Subject: La Crosse County Surveyor - For Review - CSM - Causeway Blvd 17-20251-15

The proposed Causeway Boulevard CSM has been reviewed. See comments below.

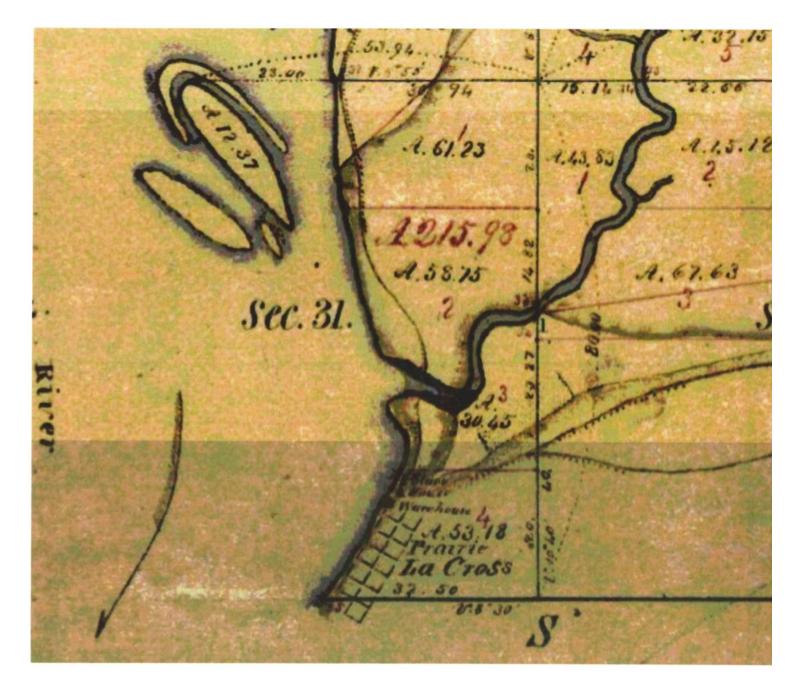
- 1. The caption on all four pages, along with the opening statement in the legal description states "located in the Northwest ¼ of the Northeast ¼". That statement is incorrect. There is no Northwest ¼ of the Northeast ¼ in Section 31. It is only Government Lot 1 as per the Original Government Plat Sheet (below). I realize that the plat of River Point District indicates that it is part of the Northwest ¼ of the Northeast ¼, but that is simply not true. Register of Deeds, Robin Kadrmas indicates that she only has tracting for Government Lot 1 in this area.
- 2. Please consider relabeling the north section line from the "NORTH LINE OF THE NE ¼ SECTION 31-16-7" to the "NORTH LINE OF GOVERNMENT LOT 1, SECTION 31-16-7.
